South Gessner Reconstruction CIP No. N-100017-0001

PROJECT INFORMATION

Summary of Public Comments Traffic Comments (pgs. 1 of 4)

Gessner - Richmond to Westheimer

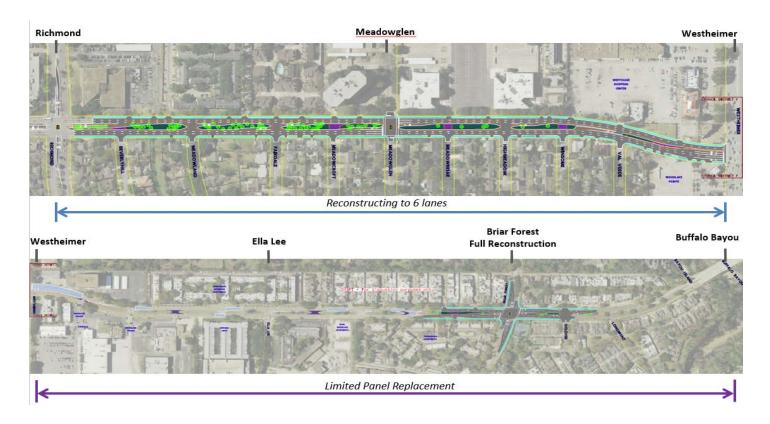
1. Do not widen Gessner, north of Westheimer, to six lanes. There is long term concern that it will eventually happen between Westheimer and I-10.

2. Widening Gessner from Richmond to Westheimer will only push the bottleneck further north. It will also attract more traffic.

3. The traffic signal at Gessner and Briar Forest needs immediate attention because it malfunctions when there is lightning, and sometimes even with light rain.

4. Some citizens think adding turn lanes at Gessner and Briar Forest will relieve problems, others think they are unnecessary and adjusting the timing of the signals could solve all of the traffic problems at the intersection. One resident suggests having double left-turns at the northbound approach of Gessner, instead of an exclusive right-turn. Another resident suggests the consideration of a roundabout.

5. Bike lanes should be removed.

6. The bus stop on the northwest corner of the Gessner and Briar Forest intersection should be relocated to the southwest corner, away from the planned exclusive right turn lane, in order to allow vehicles to turn west unimpeded. Its relocation should be considered now because traffic congestion due to a stopped bus is often observed.

7. Traffic, pedestrian, and bicycle signals need to be modernized. Traffic monitoring cameras should be implemented in order to adjust signals according to traffic demand.

8. Traffic obstruction should be kept to a minimum during construction.

9. Are there any immediate ways to help traffic flow through the Gessner and Briar Forest intersection?

10. The amount of heavy vehicles should be limited along Gessner in order to improve road quality. Many heavy vehicles use Gessner to bypass the tollway.

1. There is no plan to safely support accessibility into and out of Woodlake Forest IV Community. A traffic signal is needed for this section of the neighborhood. The current plan to add a left-turn bay at Doliver will make it difficult for drivers to access the southbound lanes of Gessner from the neighborhood. Drivers currently use the median opening to wait as the southbound vehicles at the Briar Forest intersection clear out. It would be ridiculous to make a U-turn at Longmont in order to head south along Longmont.

2. The median opening at Doliver should be closed because turns across Gessner should be discouraged.

3. Do not close the median that allows access into Randall's because it helps ease congestion during the peak traffic hours.

4. Closing the medians between Richmond and Westheimer will create more cut-through traffic for the Tanglewilde neighborhood. Can signs that say "No Thru Traffic" be added? What else can be done to prevent cut-through traffic?

5. Widening Gessner will make access to residential driveways along Gessner more dangerous than it already is.

6. Closing the median at Meadowvale will cause significant traffic to be deterred directly in front of 9671 Meadowvale and throughout the neighborhood. Are there any plans to block Meadowvale from thru traffic?

1. If traffic calming devices are the solution for cut-through traffic that will be generated from the closed medians between Richmond and Westheimer, then response by emergency vehicles will be slowed down.

2. The increased traffic that will result from this project will cause more pollution, crime, and traffic accidents. How are you going to protect the neighborhood from car pollution and noise pollution? There should be a sound barrier along the northbound lanes between Richmond and Westheimer. Kids and animals have also been hit by cars; the Tanglewilde neighborhood should have its speed limit lowered to 20 mph.

3. Drivers that speed along the southbound lanes of Gessner have wrecked the fence on Bayou Pointe more than once. The current plan will attract more traffic and cause this to happen more often. The City should pay to fix the fence every time.

4. The speed limit along Gessner should be reduced to 30 mph in order to make it safer for residents living along Gessner.

5. Make pedestrian facilities and bike lanes safe.

6. Elementary schools near the project limits are vulnerable to the negative impacts that traffic will cause. Can school zone signs be placed on all streets leading to Emerson Elementary?

1. The intersection of Gessner and Briar Forest floods with minimal rain, making it difficult for compact cars to cross the intersection. There are no new drains planned for that intersection.

2. Drainage ditches should be cleaned and dredged.

3. This project has the probability of adversely affecting drainage and flooding homes. Meadowvale, especially at its intersection with Tanglewilde, floods during heavy rain and this project will make it worse.

1. Do not destroy the medians, along with its trees and flowers that took years to develop. Tree conservation needs to take place and removal needs to be kept at a minimum.

2. Taller curbs should be used to keep cars out of the grass and trees.

3. This project will be detrimental to property values and will ruin the neighborhood, especially near the planned widening. All value could be lost if any acquisition were needed to facilitate the widening.

4. There seems to be no plan to improve the sidewalk between Windswept and Richmond, which will adversely affect the value and aesthetic appeal of the properties along Gessner. Are there any plans for sidewalk improvements south of Richmond?

5. If a grade separation at the intersection of Gessner and Westheimer is needed, it should be an underpass because a bridge would ruin the adjacent neighborhood and destroy any chance it has to retain anything resembling a truly residential character.

At this time, Gessner will not be widened to six lanes between Westheimer and Buffalo Bayou.

Widening Gessner from Richmond to Westheimer may affect traffic patterns, but it is expected to reduce congestion at intersections within the project limits.

The traffic signal at Gessner and Briar Forest will be reconstructed. Malfunctioning may occur during inclement weather and should be reported to <u>311</u> for evaluation and repairs.

The planned reconfiguration of the Gessner and Briar Forest intersection was based on a traffic analysis that included traffic counts. An option was presented to provide double left turns at each approach, but it was not possible due to existing geometric and Right-of-Way (ROW) limitations. The next best configuration was implemented into the plan. Changing the timing of the traffic signals may help, but additional lanes are necessary to provide a reasonable level of service through this intersection. A roundabout would require acquisition of additional real estate.

The bike lanes along Briar Forest will remain, as they are integral to the City's plan to provide a bike network to its residents. Measures will be taken by the design engineer to ensure safety to bike riders and drivers as they cross the Gessner intersection. Major Categories or Areas of Concern Are:

The relocation of the bus stop on the northwest corner of the intersection of Gessner and Briar Forest will be evaluated during the design process. The design team will coordinate with METRO.

Signals at all intersections will be upgraded to meet current City standards.

Construction will take place in segments that allow a reasonable and safe flow of traffic.

This project will address traffic flow by updating intersections and traffic signals to meet current City standards. For immediate assistance, please call <u>311</u> or visit the City's Traffic Operations Division at: <u>https://www.publicworks.houstontx.gov/traffic/index.html</u>.

The City does not have the jurisdiction to limit heavy trucks from using Gessner.

The design team will look closely at the accessibility in and out of Woodlake Forest IV. The need for a traffic signal for the neighborhood was not identified during planning stages, but at a minimum, measures will be taken to improve the sight distance at Doliver and Longmont.

Closing the median opening at Doliver would improve traffic through the Briar Forest and Gessner intersection, but it may disrupt accessibility to Woodlake Forest IV. The design team will take these factors into consideration during the project analysis.

The current plan would convert the first median opening north of the Westheimer intersection into a restricted left-turn lane. This configuration would improve traffic conditions at Gessner, while still allowing left turns into Randall's.

The additional lanes, closed median openings, and proper operation of traffic signals between Richmond and Westheimer should encourage drivers to stay on Gessner instead of cutting through the Tanglewilde neighborhood. Speed cushions on neighborhood streets that have a median opening at Gessner may also help deter cut-through traffic. Residents that are interested in implementing speed cushions, road signs, and other traffic-calming measures should contact the City's <u>Neighborhood</u> <u>Traffic Management Program</u>. Major Categories or Areas of Concern Are:

The widening of Gessner should not change the accessibility to residential driveways along Gessner. However, residential driveway encroachment will be evaluated during the project design analysis.

Currently, there are no plans to close Meadowvale from through traffic. Closing the median opening at Meadowvale would eliminate the ability to turn left onto Meadowvale, thus reducing traffic through Meadowvale. Major Categories or Areas of Concern Are:

The implementation of traffic-calming devices considers the effects they can have on emergency vehicles; City-standard speed cushions are designed with spacing that allows emergency vehicles with wide bases to pass through the device without having to slow down.

Sound barriers are not standard for thoroughfares similar to Gessner. Trees will be planted along the corridor, which may serve as a noise deterrent. Congestion relief provided by this project can also lead to air quality improvements. For traffic speed limitations, please contact the City's <u>Neighborhood</u> <u>Traffic Management Program</u>.

The fence damage on Bayou Pointe is a law enforcement speeding issue and will be handled by the police department. The lane configuration along this segment of S. Gessner from Westheimer to the Bayou will not change, however, limited panel replacement is being proposed.

The speed limit along Gessner will remain at 35 mph. However, immediate concerns with traffic and speed limitations should be forwarded to the City's <u>Neighborhood Traffic Management Program</u>.

Sidewalks and other pedestrian facilities will be rebuilt between Richmond and Westheimer and near the Briar Forest intersection. The bike lanes along Briar Forest will be widened as they approach the intersection at Gessner to enhance safety.

Requests to add school zone signs must be submitted through the school principal to the <u>City's School Coordination Program</u>.

The intersection of Gessner and Briar Forest will be repaved and new drainage inlets will be added in order to mitigate drainage problems at the intersection.

Requests for ditch maintenance should be submitted to the City's 311 service.

The plan for the segment between Richmond and Westheimer includes the addition of a 60-inch diameter storm system and inlets in order to provide adequate storm water conveyance for the surrounding drainage areas. Overall drainage impact from the project has been evaluated and will be confirmed during the design process.

Both the addition and removal of median space needs to take place in order to achieve a serviceable flow of traffic. The conservation and relocation of existing trees will be analyzed during the design phase and trees will be replaced or relocated where necessary.

Standard curbs are 6 inches tall and will be used throughout this project.

the improved infrastructure and drainage, proposed by this project, may lead to lend some value overall, to the neighborhood . No ROW acquisition is scheduled for the project. However, limited acquisition may occur at intersections to accommodate updated traffic signal equipment. Residents will be notified of any ROW acquisitions necessary as a result of final design.

Planned sidewalk improvements end at Richmond, but could extend south to Meadowvale in order to provide compliant facilities to pedestrians crossing Richmond. Residents outside of the project limits that wish to have sidewalk improvements must submit an application to the City's <u>Safe Sidewalk</u> <u>Program</u>.

The planned grade separation at Gessner is currently recommended as an overpass due to the higher cost and contingencies that would result from proposing an underpass. No plans or funding has been allocated to implement the recommendation at this time.
